PROJECT: Advanced Boiling Water Reactor (ABWR)

SUBJECT: SUMMARY OF MEETING WITH GE ON SEPTEMBER 9 AND 10, 1992

Proposed Disposition of NRC Comments on SLCS ITAAC

Figure 2.2.4 Standby Liquid Control System (Standby Mode)

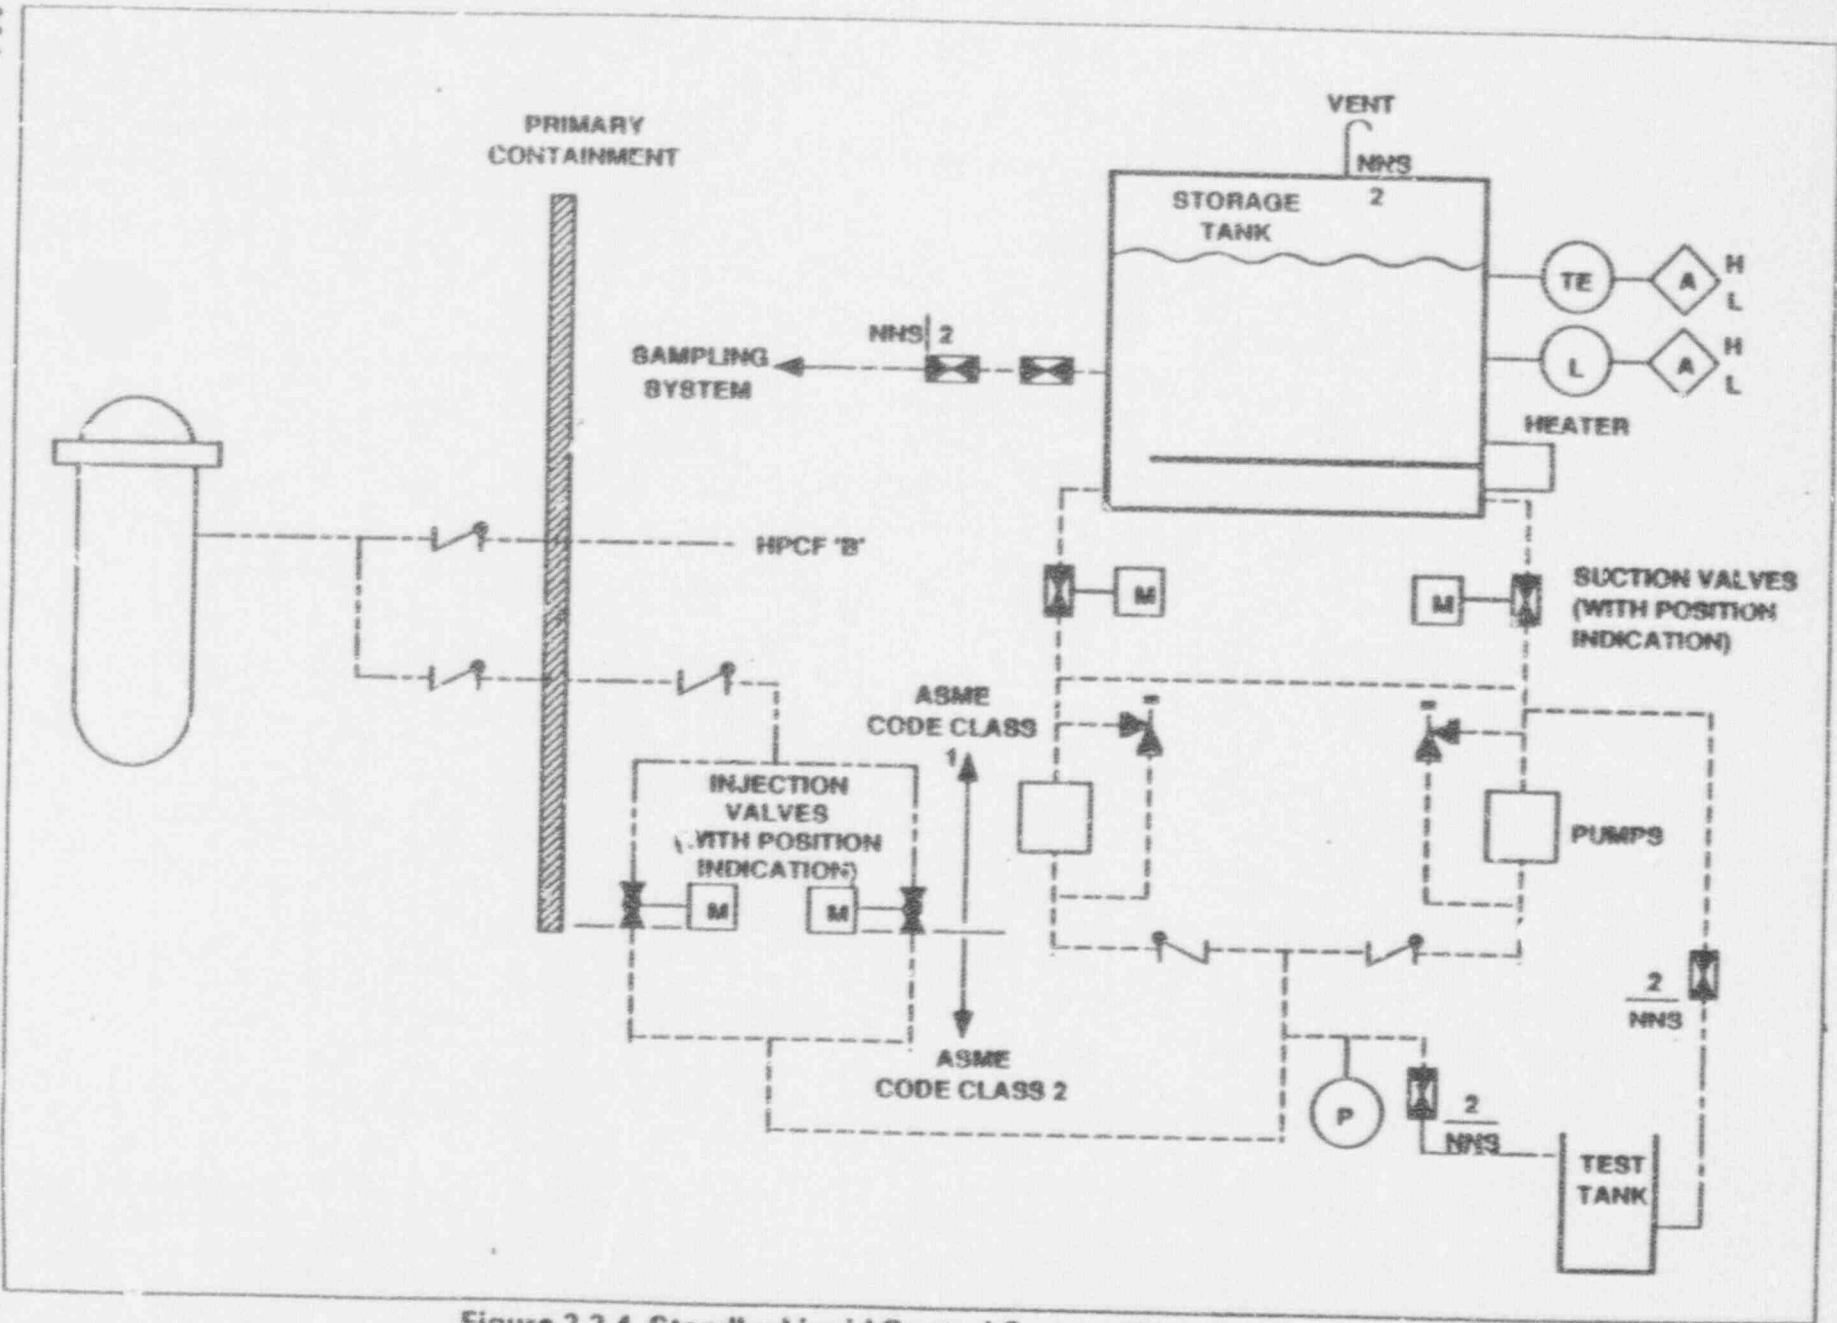
- Certified Design Commitment**
1. The minimum average poison concentration in the reactor after operation of the SLC System shall be equal to or greater than 850 ppm. ^{NATURAL BORON} IS AT LEAST 850 ppm. THE TANK CONCENTRATION IS, THEREFORE, AT LEAST 1320 ppm. THE SUM OF THE MINIMUM BORON CONCENTRATION TO ACHIEVE COLD SHUTDOWN (850 ppm), AND AN IMPERFECT MIXING MARGIN (250 ppm), AND A DILUTION MARGIN (250 ppm).
2. A simplified system configuration is shown in Figure 2.2.4. FOR THE SLC SYSTEM IS DESCRIBED IN SECTION 2.2.4.

- Storage tank pumpable volume range 6100-6800 gal. 23.1 - 25.7 m³
 - RPV water inventory $\leq 1.09 \times 10^6$ lb ^{455 * 10³ kg}
 - RHR shutdown cooling system inventory $\leq 0.267 \times 10^6$ lb ^{130 * 10³ kg}
2. The ^{AS-BUILT} system configuration is in accordance with Figure 2.2.4. THE DESCRIPTION IN SECTION 2.2.4.

2. Revise the table 2.2.4 item #2 to show that the system configuration and construction drawings are in accordance with Tier 1 design commitments. Criteria should not specify that system configuration is in accordance with figure 2.2.4, because that simplified figure will not correspond in detail to as built system. This is a generic comment and applies to all systems.

GE Response: The level of detail in the SLCS diagram is consistent with that of other systems. The ITAAC has been revised to reflect the system description in the Design Document rather than just the figure.

GE Response: ITAAC Item #2 has been revised to show that the as-built design conforms with the system description.

Figure 2.1.2a Safety/Relief Valves and Steamline

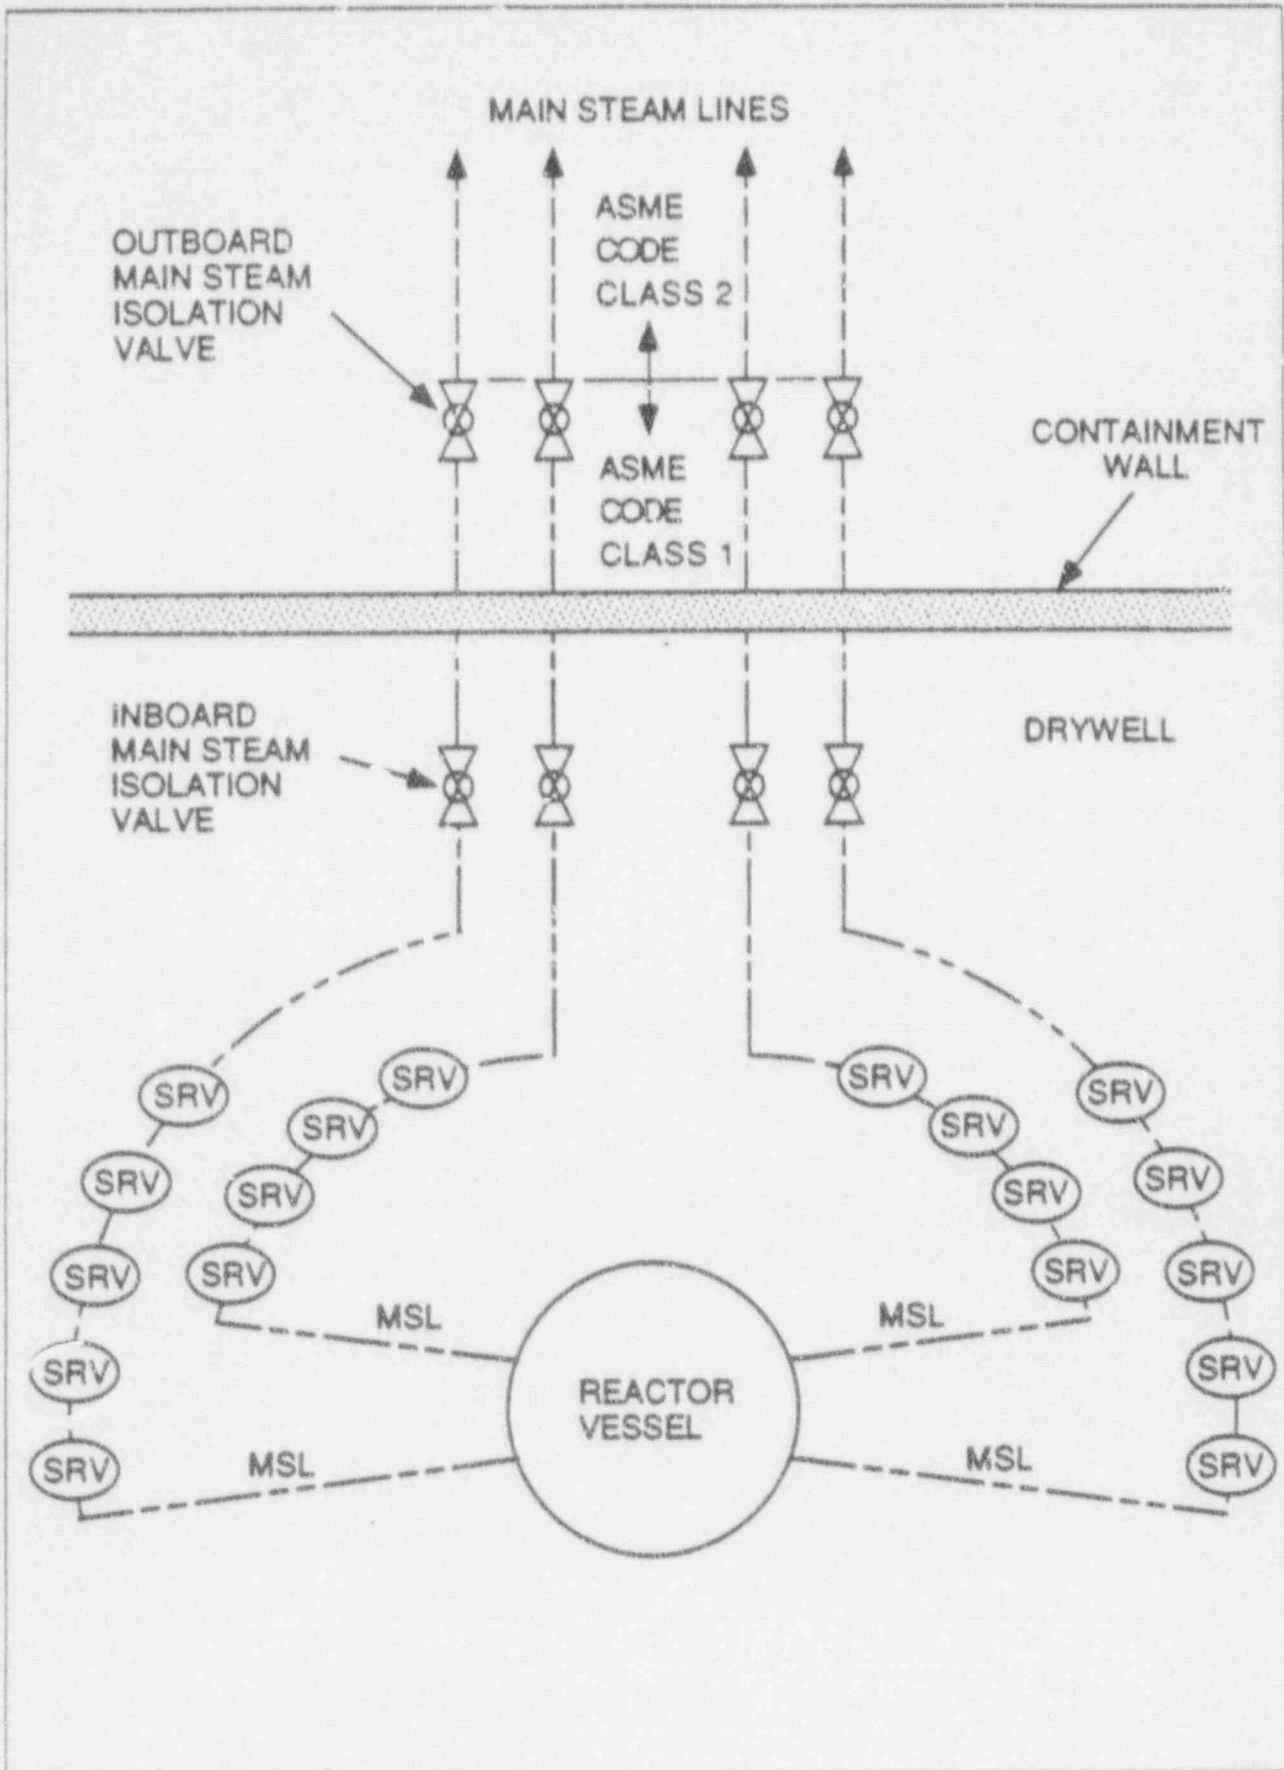
9. There shall be ^{ARE} 18 SRVs mounted on the MSLs as shown in Figure 2.1.2a. The required spring set pressure and capacities are given in Table 2.1.2a. The SRVs shall meet the opening performance shown in Figure 2.1.2f.	9. Inspections will be conducted to confirm that the SRVs have the required (nominal) spring set pressure and (minimum) capacity on the SRV nameplate. Visual inspections will be conducted to confirm that all 18 SRVs have been installed in their proper locations. TO REVIEW THE AS-BUILT SRVs. Review of the qualification test data for the particular SRV model selected to confirm that the opening performance complies with the requirements.	9. Inspection confirm that the SRVs have the required capacities and set pressures Identify SRV name plates. SHOW DATA FROM TABLE 2.1.2a. Inspections confirm that the proper capacity and set pressure SRV has been mounted in its correct location. ALL 18 SRVs WERE INSTALLED. Confirm that the selected SRV model satisfies the performance requirements of FIGURE 2.1.2f.

Figure 2.1.2b Steamline

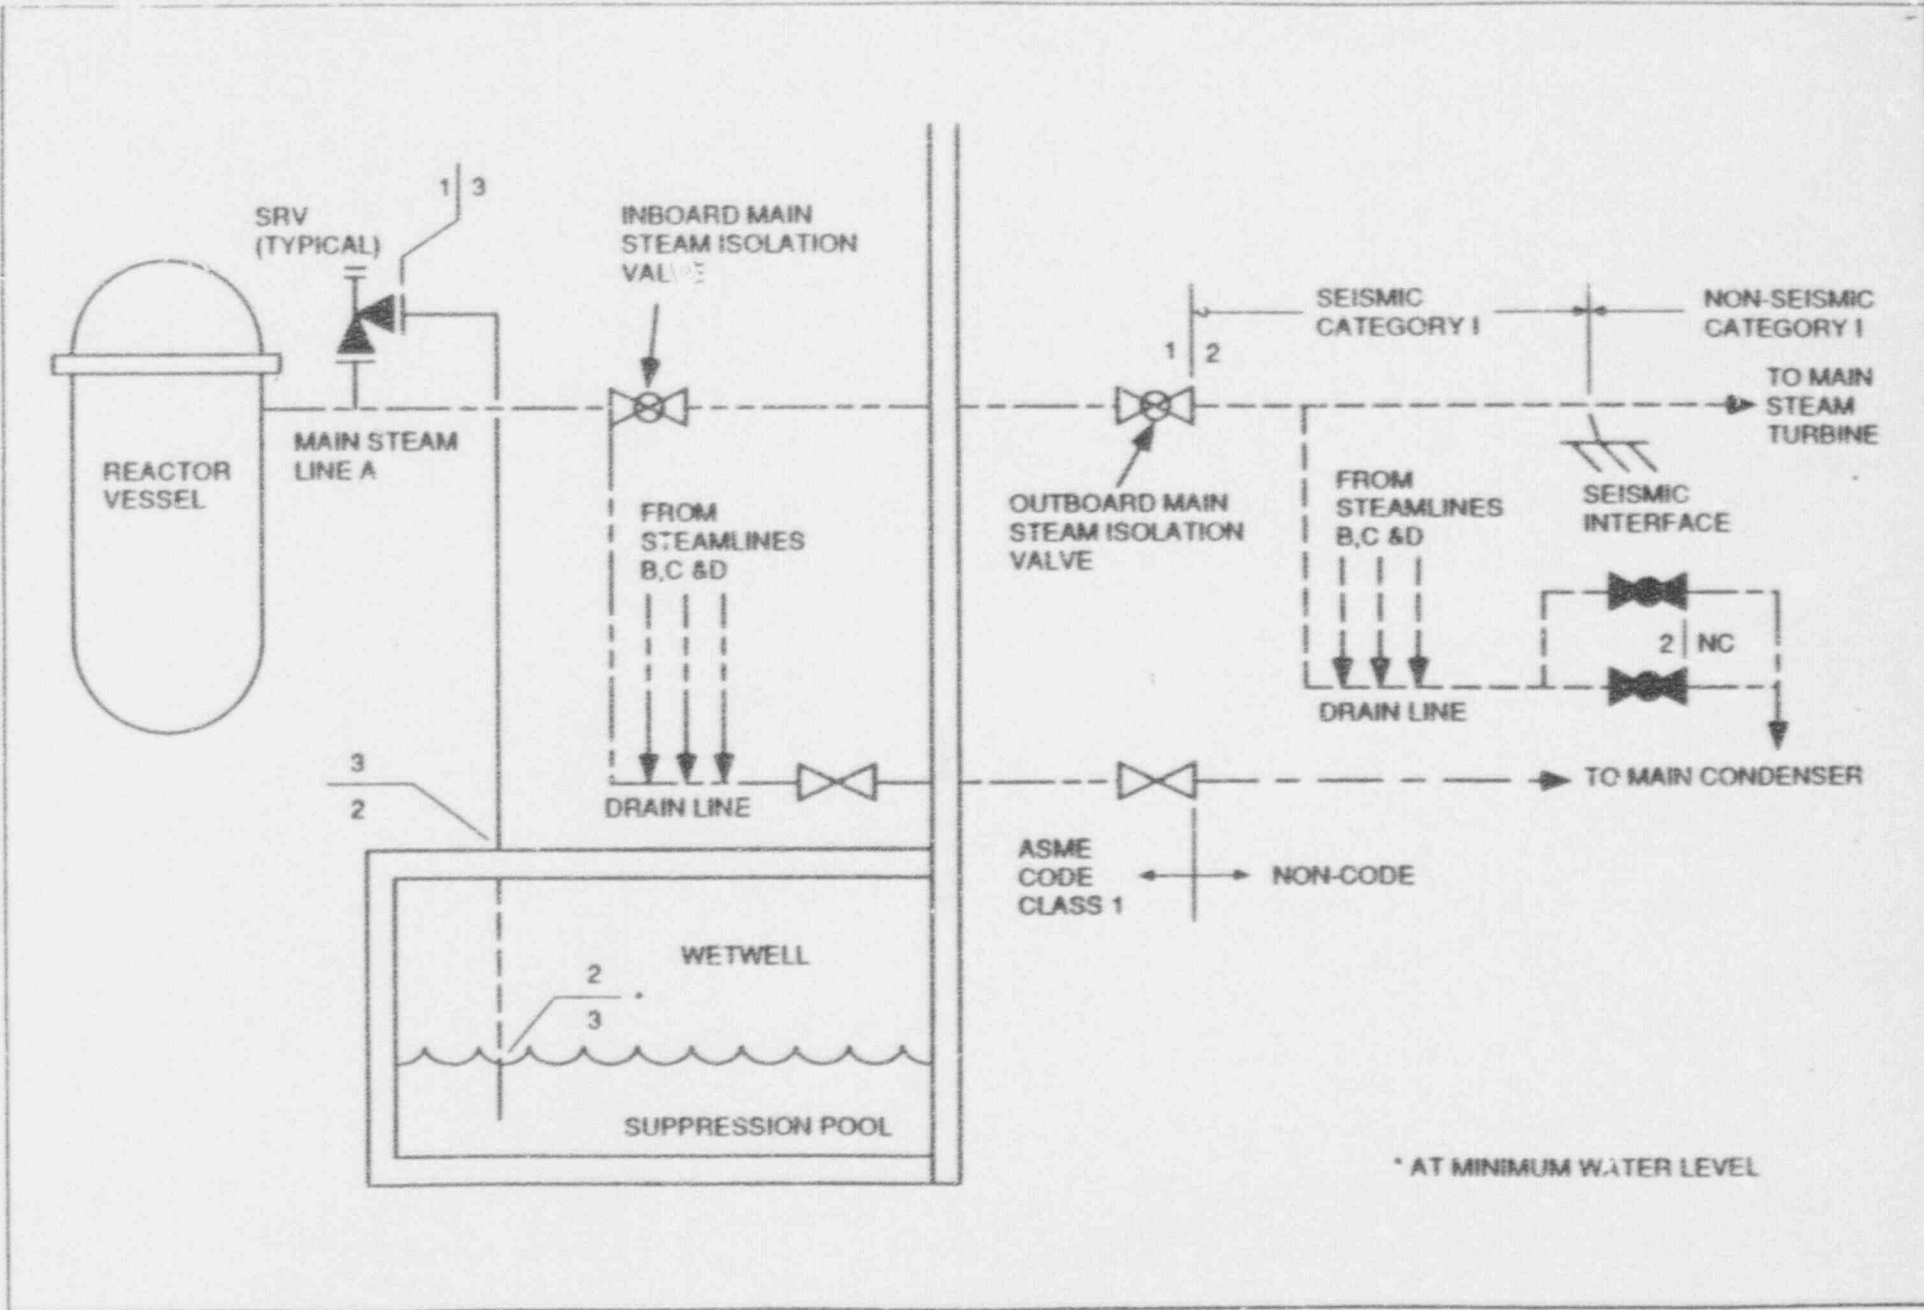
The main steam lines are Quality Group A from the RPV out to and including the outboard MSIVs, and Quality Group B from the outboard MSIVs to the turbine stop valves. They are Seismic Category I from the reactor pressure vessel out to the seismic interface ^{shown on figure 2.1.2 b.}

Figure 2.1.2d Safety/Relief Valve Pneumatic Lines

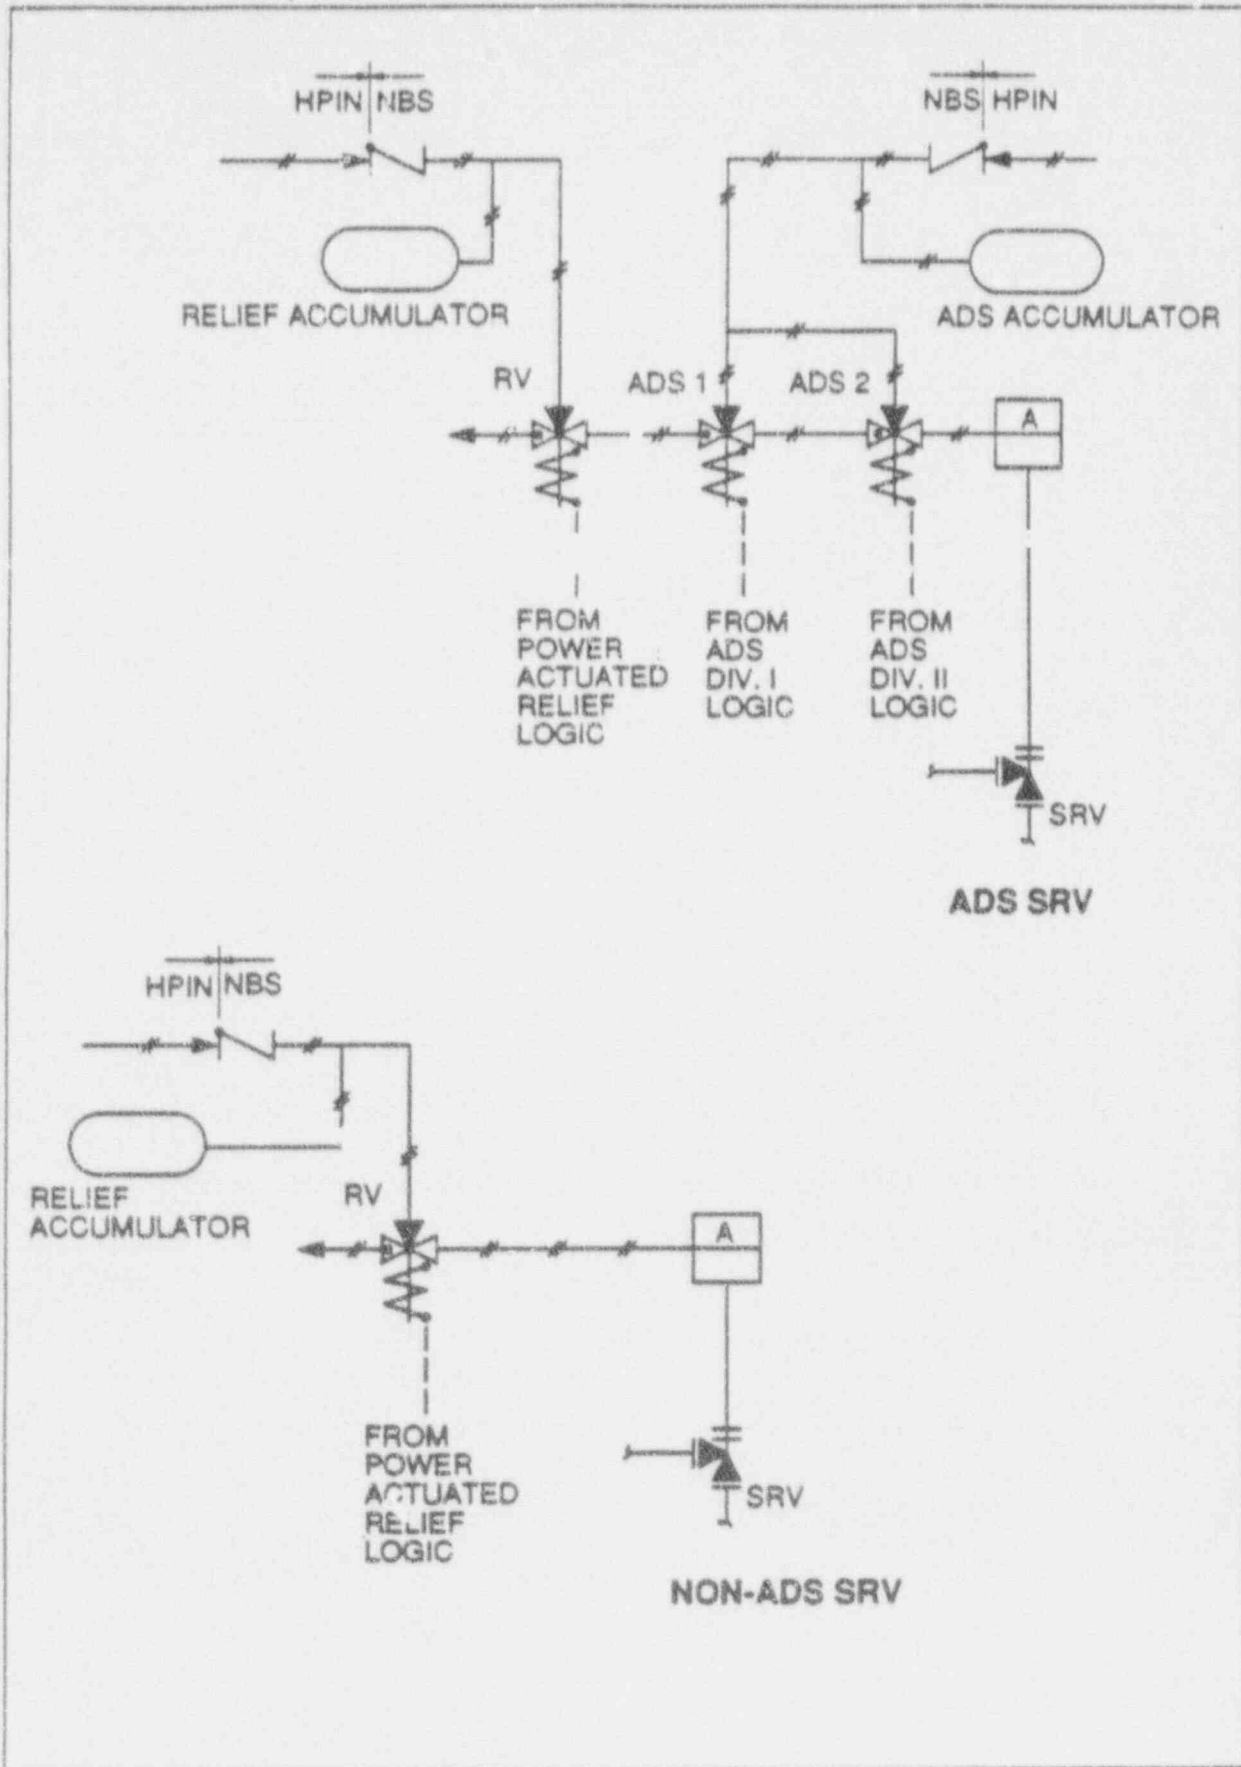
11. A simplified configuration of the Automatic Depressurization System (ADS) SRVs and the non-ADS SRVs as described in Section 2.1.2 and Figure 2.1.2.d. There are 8 ADS SRVs and 18 non-ADS SRVs.	11. Visual field inspection will be conducted to confirm that the installed equipment is in compliance with Figure 2.1.2d.	11. The configuration is in accordance with Figure 2.1.2d.
